WE12 - Replacing Vacuum Line For Exhaust Flaps (Workshop Campaign)

Revision: **March 11, 2015**

This revision amends WE12 as follows:

Vehicle Type: **911 Carrera S (991)/911 Carrera 4S (991)**

**Information**

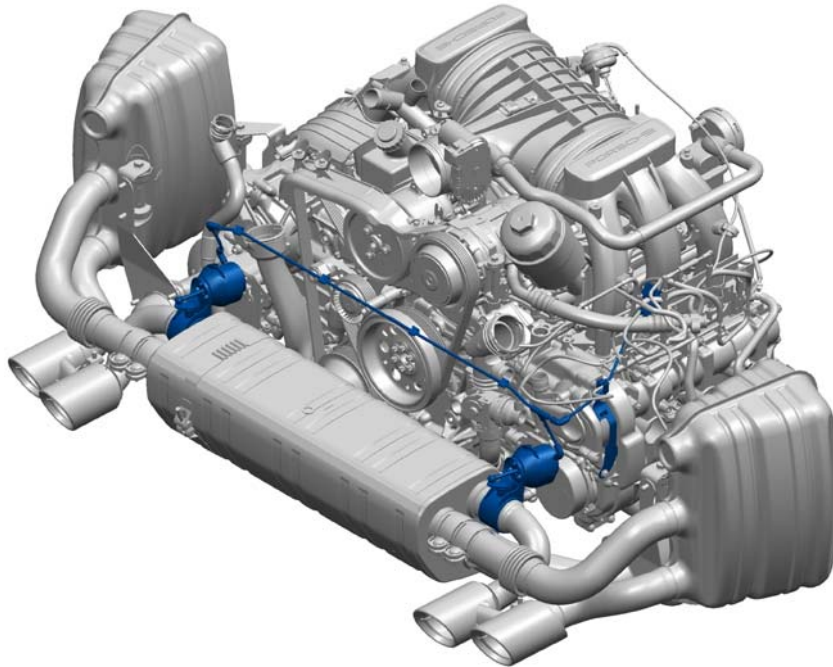
A modified vacuum line for exhaust flaps is available with immediate effect.

This modified vacuum line further improves the routing of the line to prevent it from slipping off the exhaust flaps.

Only the new vacuum line specified below must therefore be used from now on for carrying out this campaign.

This measure does not have to be carried out again on vehicles on which the vacuum line has already been replaced as part of this campaign.

Part No.	Designation	Qty.
000.043.209.86	⇒ Vacuum line, complete	1 ea.

Installation position of line brackets at the left

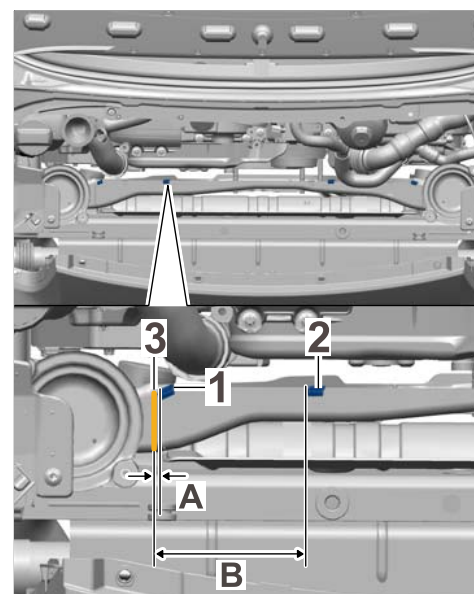
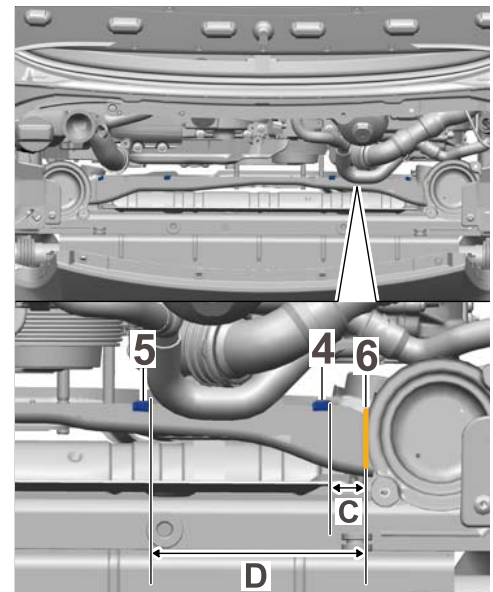
- 7 Check position of line brackets for the vacuum line.
 - 7.1 Measure the position of the line brackets ⇒ *Installation position of line brackets at the left -1, 2-* at the **left side** of the engine carrier. To do this, use a steel rule or measuring tape to measure the distance ⇒ *Installation position of line brackets at the left -A, B-* between the bead ⇒ *Installation position of line brackets at the left -3-* on the left engine carrier and the corresponding line bracket.

If the line brackets are not fitted at the correct distance from the bead, carefully prise the line brackets off the engine carrier and fit them at the specified distance on the engine carrier. Then check that the line brackets are fitted securely.

If the line brackets can be pulled off the engine carrier by hand using only a small amount of force, they must be removed and new line brackets (Part No. 999.651.401.01) must be fitted at the relevant position.

Line bracket ⇒ <i>Installation position of line brackets at the left -1-</i>	Distance to bead on left engine carrier ⇒ <i>Installation position of line brackets at the left -dimension A-</i> : The installation position is at the left bend (angled edge) of the engine carrier.	12 mm (+/- 1 mm)
Line bracket ⇒ <i>Installation position of line brackets at the left -2-</i>	Distance to bead on left engine carrier ⇒ <i>Installation position of line brackets at the left -dimension B-</i> :	200 mm (+/- 1 mm)

Installation position of line brackets at the right

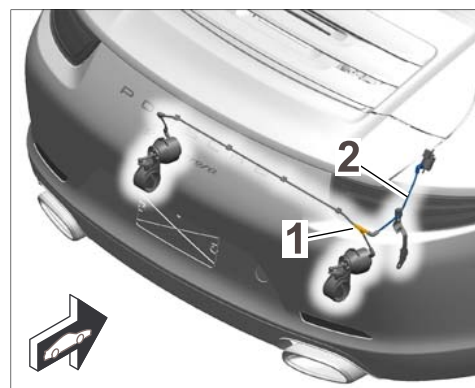
- 7.2 Measure the position of the line brackets ⇒ *Installation position of line brackets at the right -4, 5-* at the **right side** of the engine carrier.

To do this, use a steel rule or measuring tape to measure the distance ⇒ *Installation position of line brackets at the right -C, D-* between the bead ⇒ *Installation position of line brackets at the right -6-* on the right engine carrier and the corresponding line bracket.

If the line brackets are not fitted at the correct distance from the bead, carefully prise the line brackets off the engine carrier and fit them at the specified distance on the engine carrier. Then check that the line brackets are fitted securely.
 If the line brackets can be pulled off the engine carrier by hand using only a small amount of force, they must be removed and new line brackets (Part No. 999.651.401.01) must be fitted at the relevant position.

Line bracket ⇒ <i>Installation position of line brackets at the right -4-</i>	Distance to bead on right engine carrier ⇒ <i>Installation position of line brackets at the right -Dimension C-</i> :	60 mm (+/- 1 mm)
Line bracket ⇒ <i>Installation position of line brackets at the right -5-</i>	Distance to bead on right engine carrier ⇒ <i>Installation position of line brackets at the right -dimension D-</i> :	257 mm (+/- 1 mm)

Positioning vacuum line

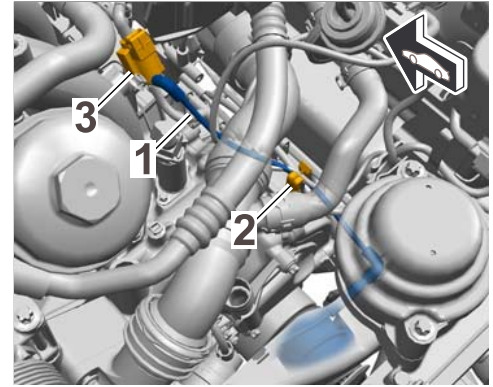
A modified vacuum line for exhaust flaps is available with immediate effect. This modified vacuum line further improves the routing of the line to prevent it from slipping off the exhaust flaps. Only the new vacuum line specified below must therefore be used from now on for carrying out this campaign.
 This measure does not have to be carried out again on vehicles on which the vacuum line has already been replaced as part of this campaign.

8 Install new vacuum line, Part No. 000.043.209.86.

8.1 Position vacuum line in the engine compartment in such a way that the T-shaped connection piece ⇒ *Positioning vacuum line -1-* is close to the **right** exhaust flap and the short section ⇒ *Positioning vacuum line -2-* is routed forward on the **right** side of the vehicle.
